COMMISSION IMPLEMENTING REGULATION (EU) 2018/502

amending Implementing Regulation (EU) 2016/799 laying down the requirements for the construction, testing, installation, operation and repair of tachographs and their components

**Figure 1 Issuance and usage of different generations of ERCA root certificates, ERCA link certificates, MSCA certificates and equipment certificates**

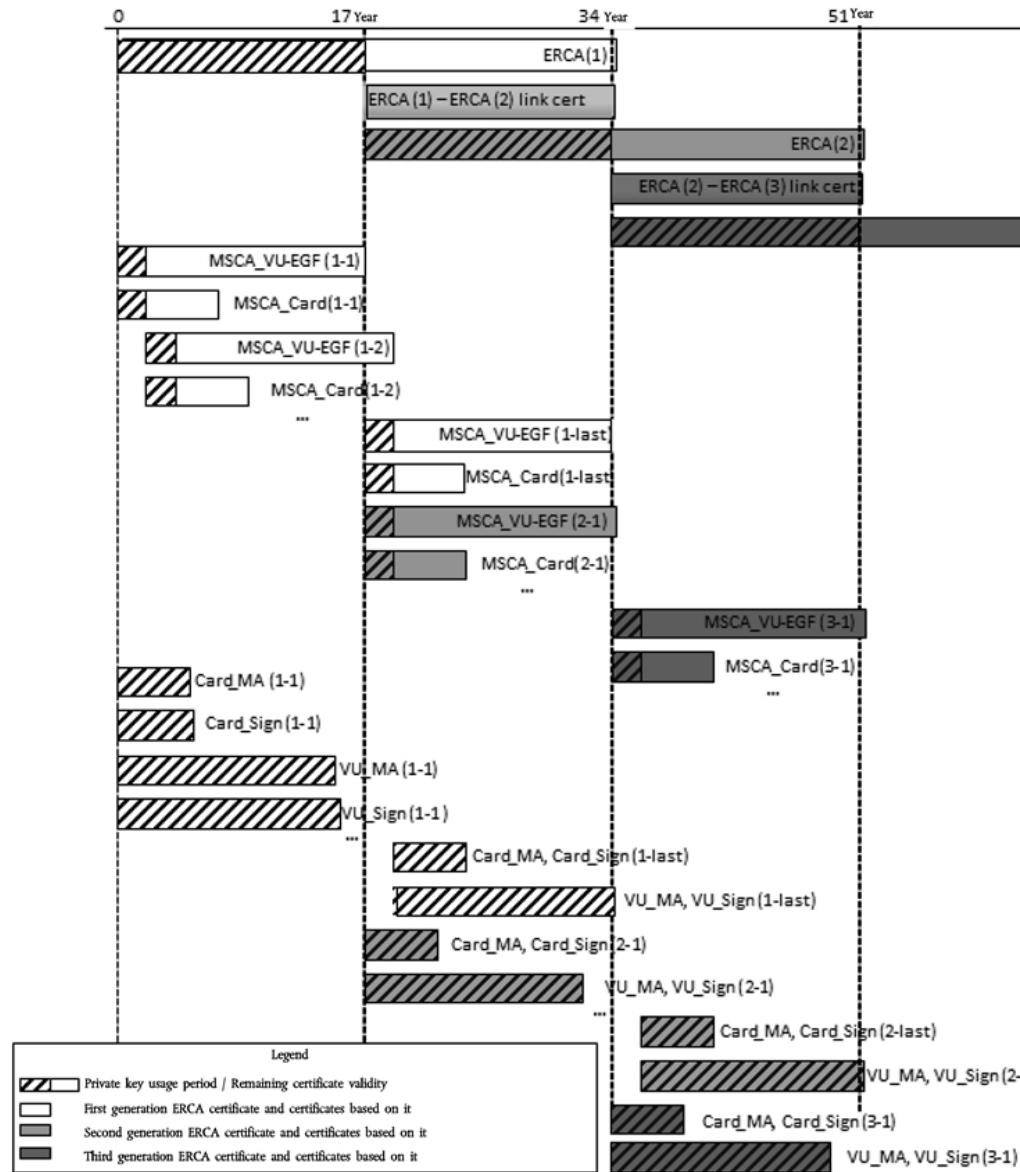
(i) Figure 1 is replaced by the following:

**Figure 6 VU Authentication protocol**

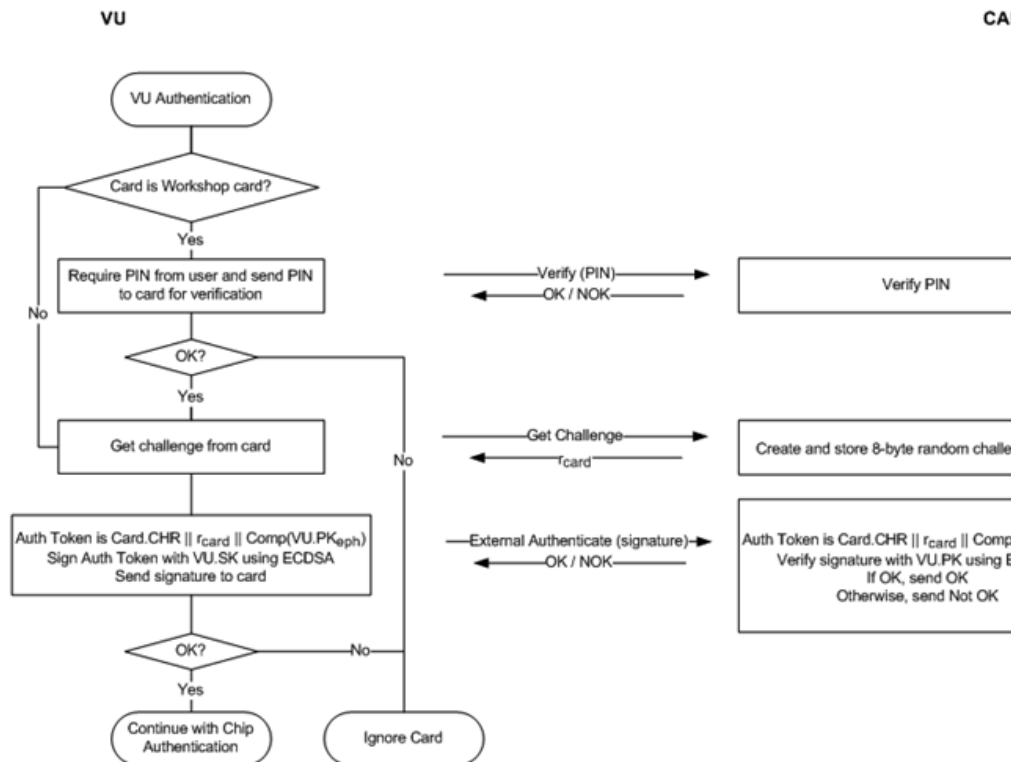
- (p) point 10.3 is amended as follows:
- (i) the first sub-paragraph in paragraph CSM\_170 is replaced by the following:
- Next to the card challenge, the VU shall include in the signature the certificate holder reference taken from the card certificate.;
- (ii) in paragraph CSM\_171, Figure 6 is replaced by the following:

*Figure 13* **Protocol for verification of the signature over a downloaded data file**

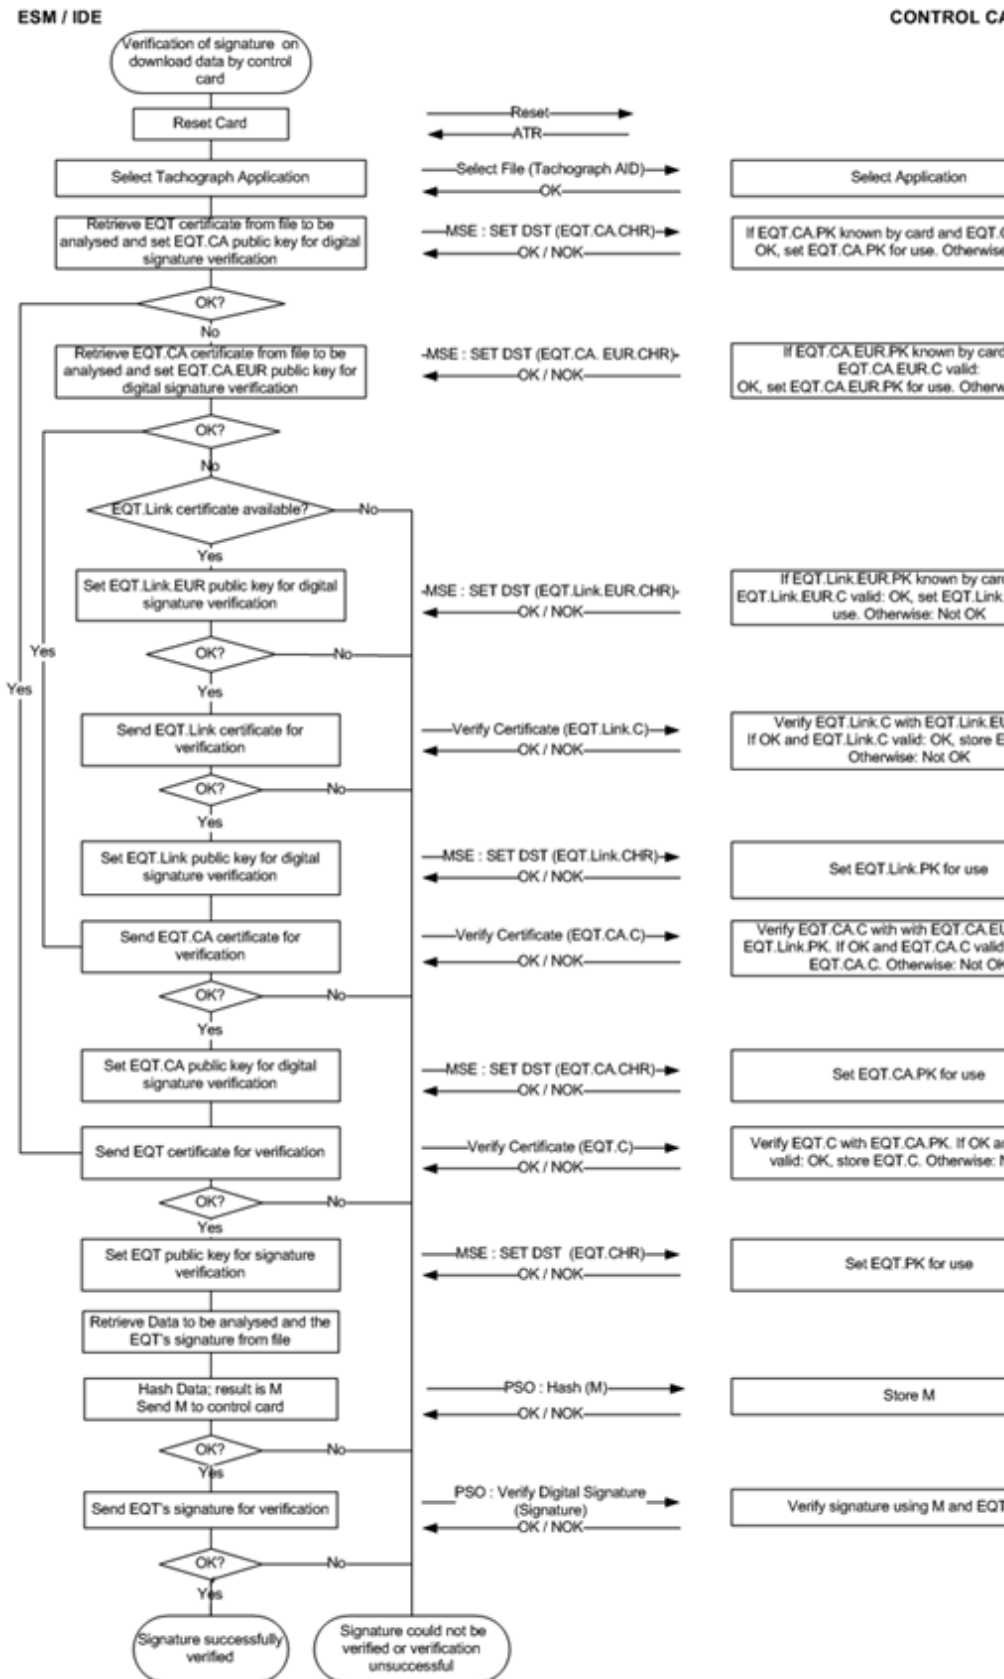
(ii) Figure 13 is replaced by the following:
